# Access Compliance Report

## Public Rights-of-Way

### (Curb Ramps)

Intersection ID: 13404	Main Street: LEXINGTON_AV	Cross Street: E_CARSON_BV	Location: SE
ADA ID: 850E7F2547F2	Ramp Type: BlendTrans2	Initial Pass/Fail: Fail	Overall Compliance: No
		Severity Score: 10

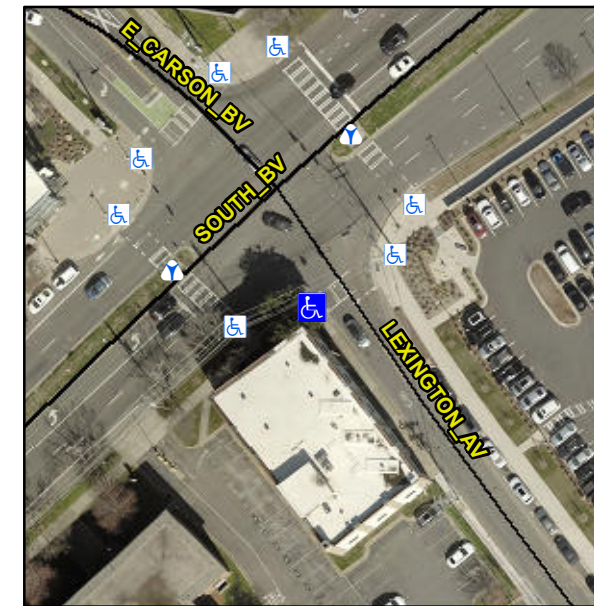
**Remove & Replace Curb Ramp With Two New Directional Ramps or Equivalent.**

**Not Found, R304.5.1**

Compliance	Description	Data	Compliance	Description	Data
N/A	Ramp Length (in)	56.0	Yes	BlendTrans Slope (%)	0.9
No	Ramp Width (in)	47.0	Yes	BlendTrans XSlope (%)	3.9
N/A	Flare Type LT	N/A	N/A	Flare Type RT	N/A
N/A	Flare Slope LT (%)	N/A	N/A	Flare Slope RT (%)	N/A
N/A	Flare Traversable LT?	N/A	N/A	Flare Traversable RT?	N/A
N/A	Landing Length (in)	N/A	N/A	DWS Provided?	N/A
N/A	Landing Width (in)	N/A	N/A	DWS Contrast?	N/A
N/A	Landing Slope (%)	N/A	N/A	DWS Length (in)	N/A
N/A	Landing X Slope (%)	N/A	N/A	DWS Full Width?	N/A
N/A	Landing Curb? (Y/N)	N/A	N/A	DWS Offset (in)	N/A
N/A	Shared Landing?	N/A			
N/A	Gutter Ponding?	N/A	N/A	Gutter Slope (%)	N/A
N/A	Gutter Lip Ht (in)	N/A	N/A	Gutter X Slope (%)	N/A
N/A	Painted X Walk1?	Yes	N/A	Painted X Walk2?	N/A
	X Walk 1 Direction	To NE		X Walk 2 Direction	N/A
	X Walk 1 Width (in)	112.0		X Walk 2 Width (in)	N/A
	X Walk 1 Slope (%)	2.6		X Walk 2 Slope (%)	N/A
	X Walk 1 X Slope (%)	4.9		X Walk 2 X Slope (%)	N/A

N/A	Ramp inside XWalk1?	Yes	N/A	Ramp inside XWalk2?	N/A
	Road Slope (%)	4.9		Clear Space?	N/A
	Road X Slope (%)	2.6	N/A	Clear Space to XWalk (in)	N/A
N/A	Any Obstructions?	N/A	N/A	Storm Grate/Utility Hazard?	N/A
	Obstruction Type			Storm Grate/Utility Type	
		N/A			N/A
			Yes	Surface Condition? (G/P)	Good
			No	Curb Slope (%)	7.9
